ADDENDUM #1

Date:	25 November 2008
To:	Abatement Contractors
From:	Bill Bowen, Project Manager, DFCM
Reference:	University of Utah College of Nursing Seismic Renovation & Remodel
DFCM Project #:	07260750
Subject:	**Addendum No. 1**

University of Utah College of Nursing Renovation

ADDENDUM NO. 1
November 25, 2008

SUB BASEMENT DEMOLITION PLAN

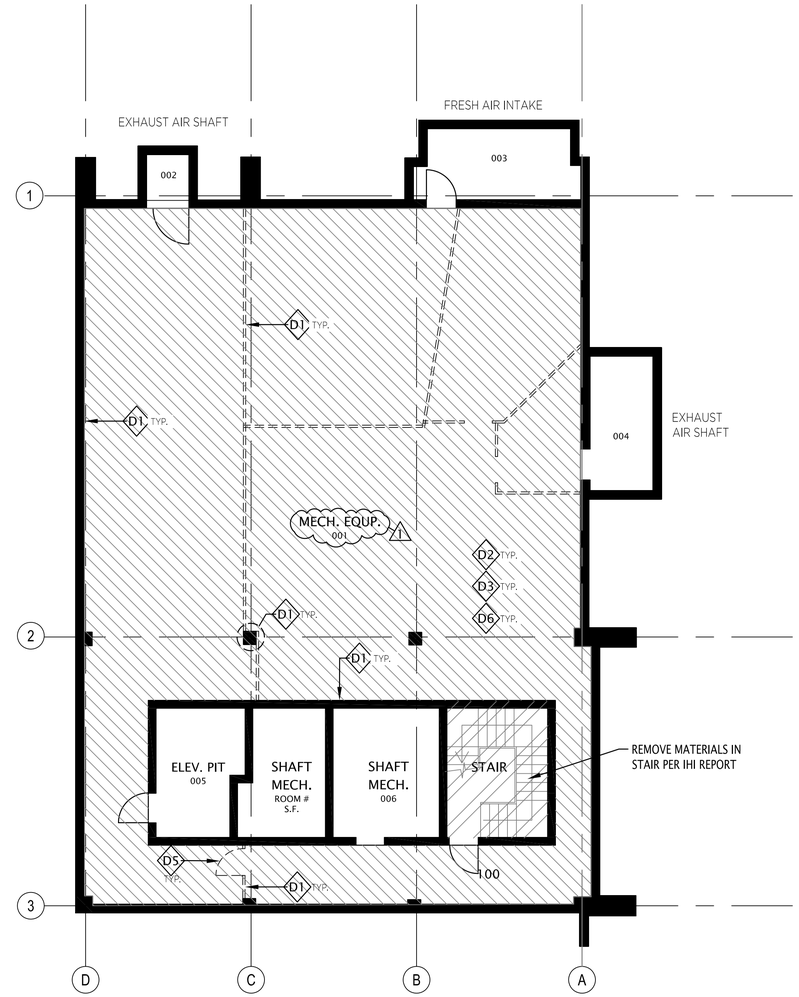
11 Question: Is the Sub-Basement Mechanical Room (complete) Demolition a part of the Asbestos Abatement Contractors Scope of Work; and if so where in the Specifications is this manifest?

Response: *Yes, abatement and demolition of all equipment (exceptions noted) in the Sub-basement is part of this scope of work. A Sub-basement demolition drawing will be issued.*

LEVEL 2 DEMO RCP

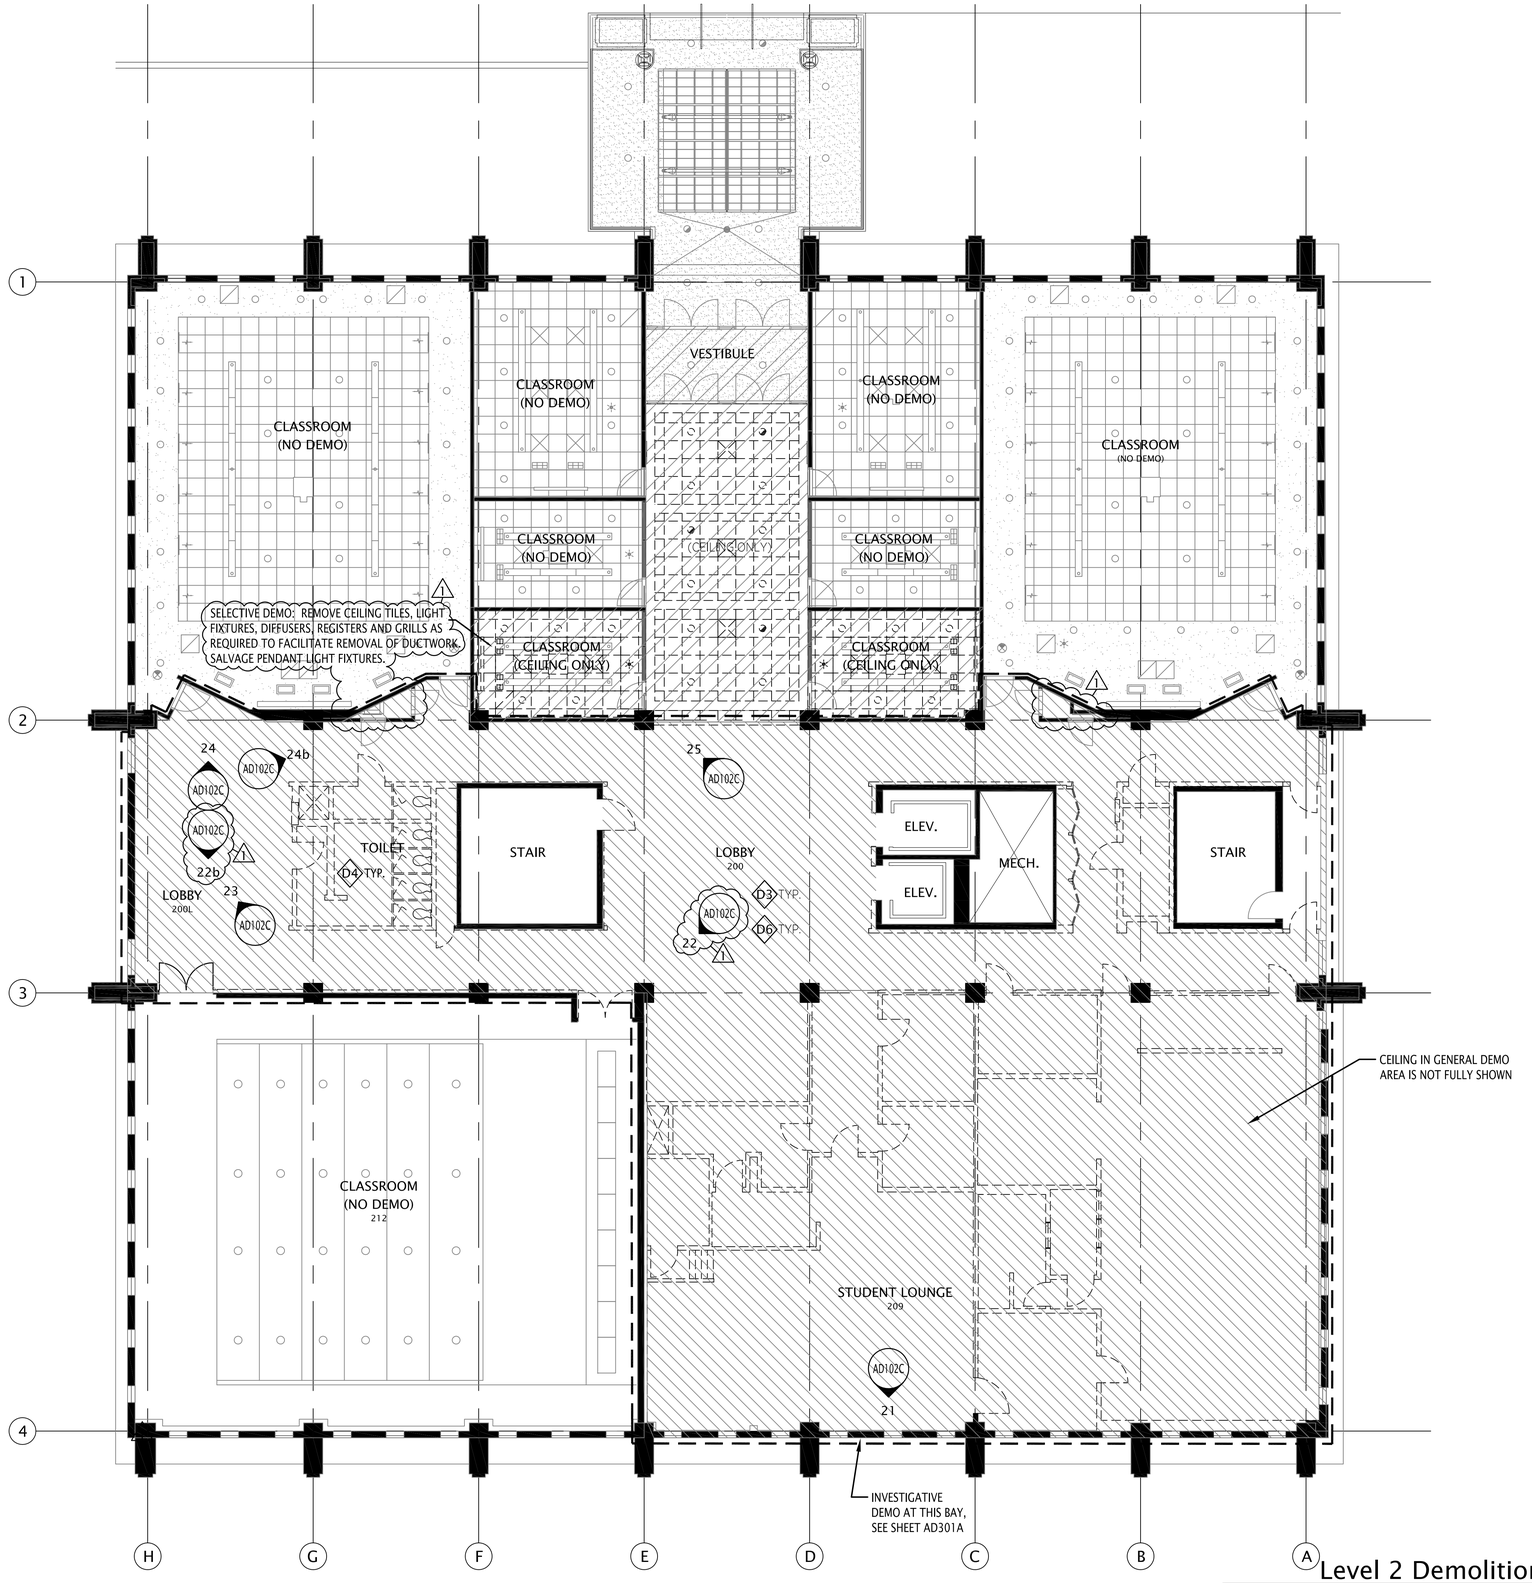
6 Question: AD102B in the newly renovated areas it shows ceiling demo, on page M101 the diffusers and register and grills in 2 classrooms are to not identified

Response: *Only remove what is required to facilitate removal of ductwork.*

MK101

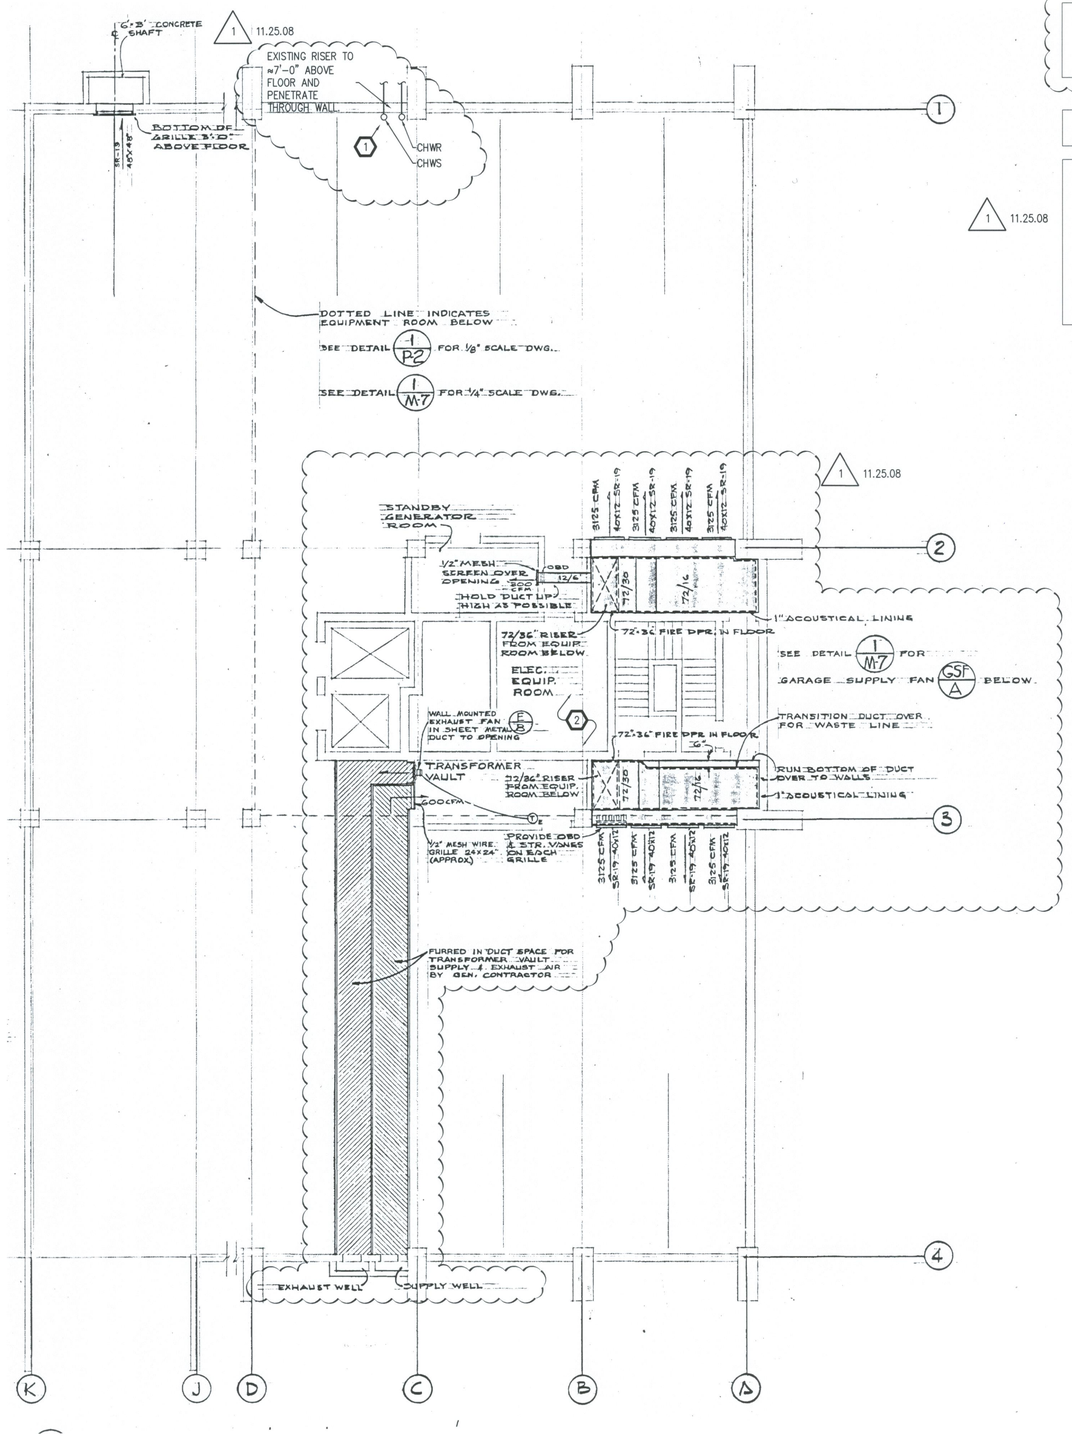
7 Question: MK101 No Demo indicated?

Response: *Refer to revised drawings.*

SHEET TITLE
LEVEL 2 ELECTRICAL DEMOLITION PLAN

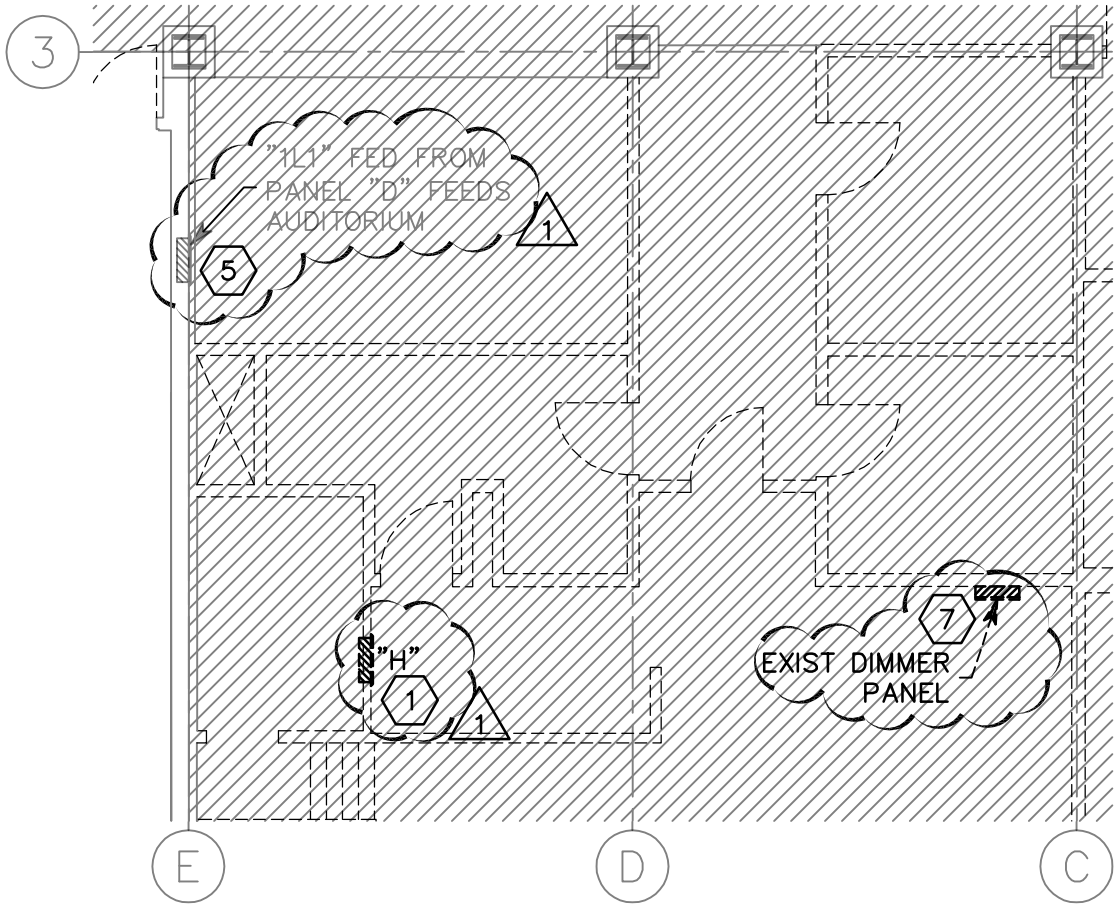
c. Sheet ED102:

1. Refer to attached revision sheet ED102-R1 for additional demolition information on this level.

7. REMOVE EXISTING DIMMER PANEL WITH ASSOCIATED CONDUIT AND WIRING.
